### TRANSMITTAL OF RESPONSES TO OHIO ENVIRONMENTAL PROTECTION AGENCY COMMENT RESPONSES ON THE DRAFT INTEGRATED REMEDIAL DESIGN PACKAGE FOR THE AREA 3 LIME SLUDGE PONDS

**RESPONSES TO OHIO ENVIRONMENTAL PROTECTION AGENCY COMMENT  
RESPONSES ON THE DRAFT INTEGRATED REMEDIAL DESIGN PACKAGE  
FOR THE AREA 3 LIME SLUDGE PONDS  
(REVISION B)**

V/FCN20500PSP1-10

PROJECT TITLE: PSP for Area 7 WAC Attainment Sampling of Area 7 Soils

FIGURE 1-1. CONSTRUCTION LAYDOWN SAMPLING LOCATIONS

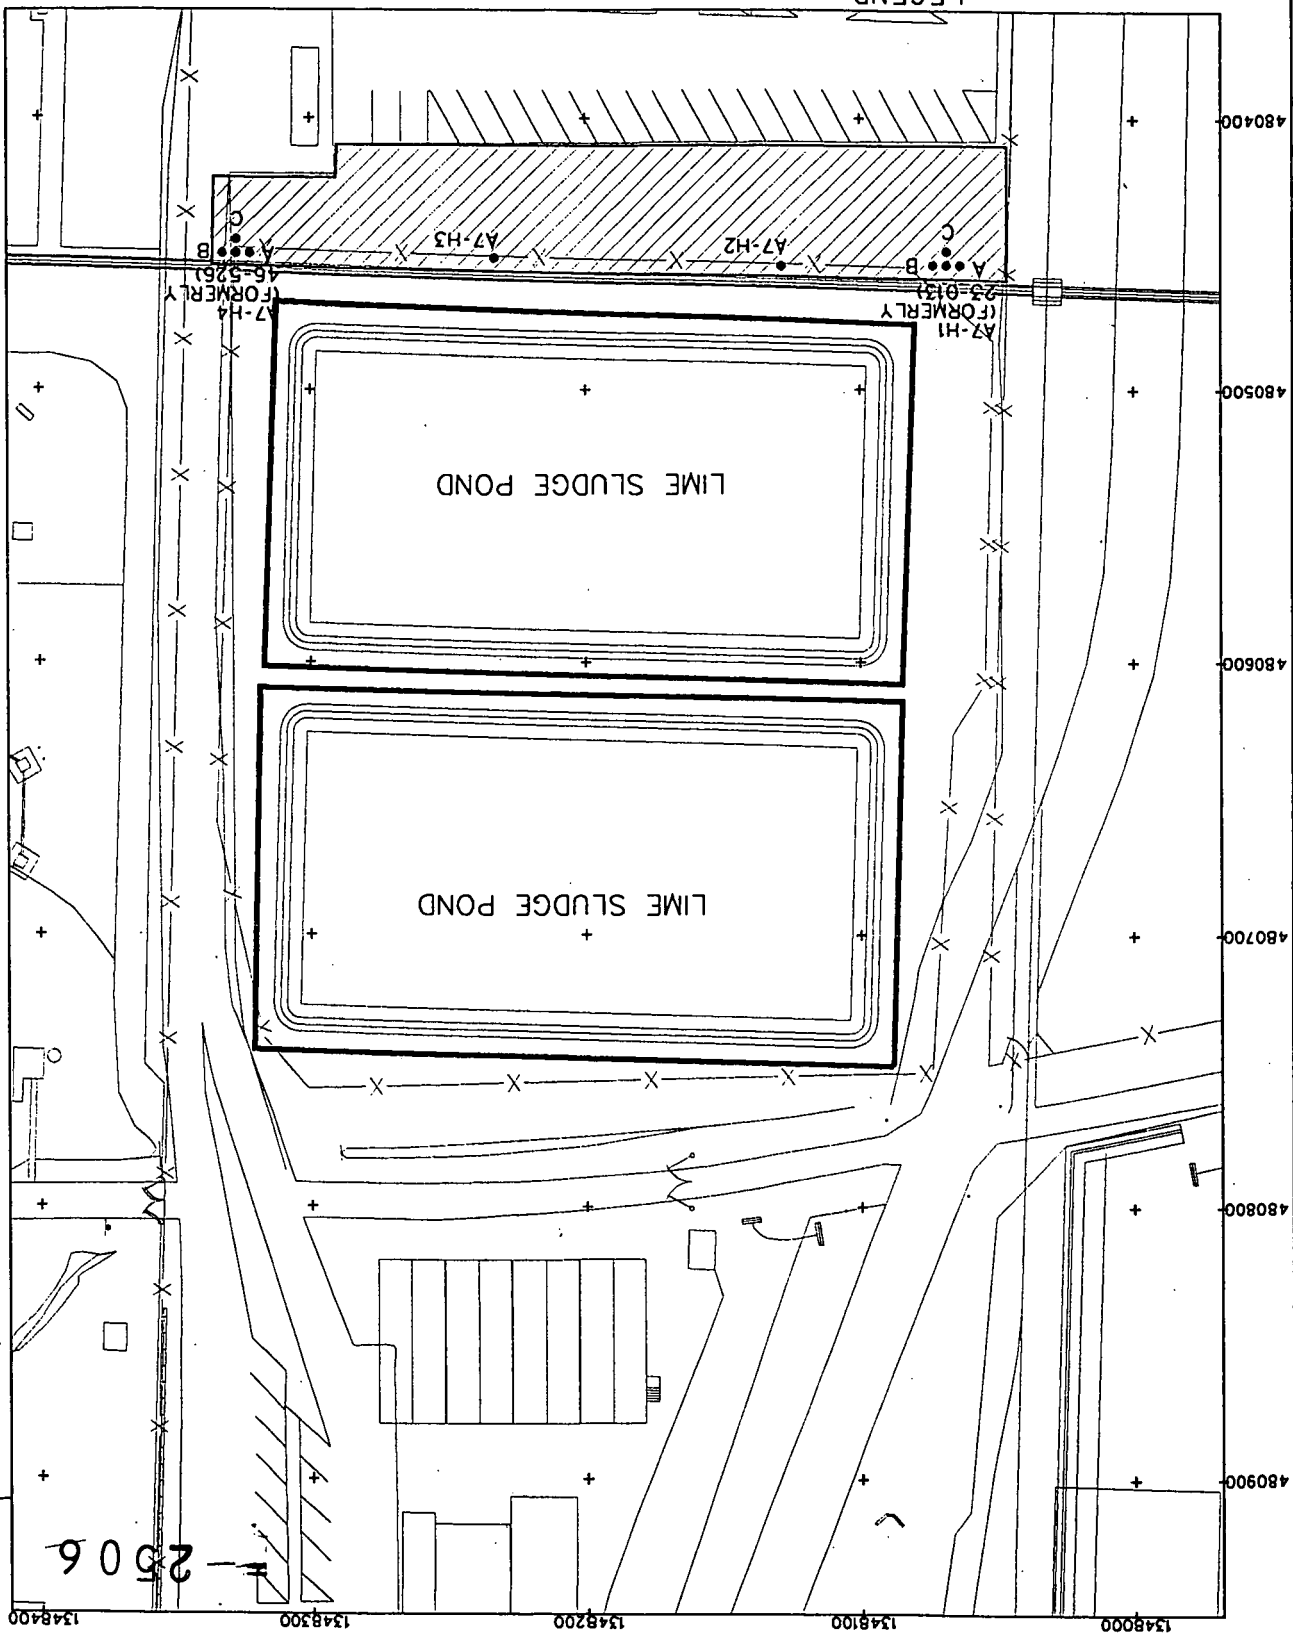
- 1)      Commenting Organization: OEPA      Commentor: OFFO  
Section #:      Page #:      Line #:      Code: C  
Original Comment #: 1  
Comment:      The proposed method for using the above WAC area south of the K-65 trench is still not acceptable to the Ohio EPA. Areas which contain known above-WAC contamination are not to be disturbed in any way. An alternative area will need to be identified.

This V/FCN is for physical soil sampling on the south side of the K-65 trench near the Lime Sludge Pond (LSP) not originally covered in the PSP. This relatively level area is approximately 250 feet long by 40 feet wide and is currently vegetated with grass. The area for WAC attainment review is bounded to the north by the K-65 trench and LSP, to the east by the Hooperville access road and to the south by the building 45 parking lot. For the purposes of this PSP, this area is designated as Area H.

Physical samples will be collected at the following four locations to a depth of four feet from the surface. Two of the sample locations, A7-H1 and A7-H4, are located at previous CIS sample locations 23-013 and 46-526, respectively. These locations exhibited above-OSDF WAC concentrations for technetium-99 at the surface (23-013 was 91 pCi/g and 46-526 was 37 pCi/g). In addition, bounding sampling to 4 feet in depth [involving three cardinal compass locations: west (A), east (B), and south (C)] will be conducted around A7-H1 and A7-H4. The sample locations are depicted in the attached Figure 1-1.

- Response:      Due to the physical constraints of this area, DOE is proposing to maintain this area south of the K-65 trench as the contractor support area. To address concerns regarding the presence of above-WAC material in the area, sampling will be conducted in the area to determine the vertical limits of the above-WAC contamination. Attached to these responses to comments is the variance to an existing approved PSP for Area 7 (which the Lime Sludge Ponds are located within), showing the sample locations. The area will be excavated to remove the above-WAC material and any necessary back filling will be placed using clean material from the Borrow Area.

- Action:      DOE will conduct sampling in the area south of the K-65 trench in an effort to identify the vertical extent of above-WAC contamination (see attached variance for sample locations). Based on the sampling results, the area will be excavated followed by the establishment of the contractor's support area.
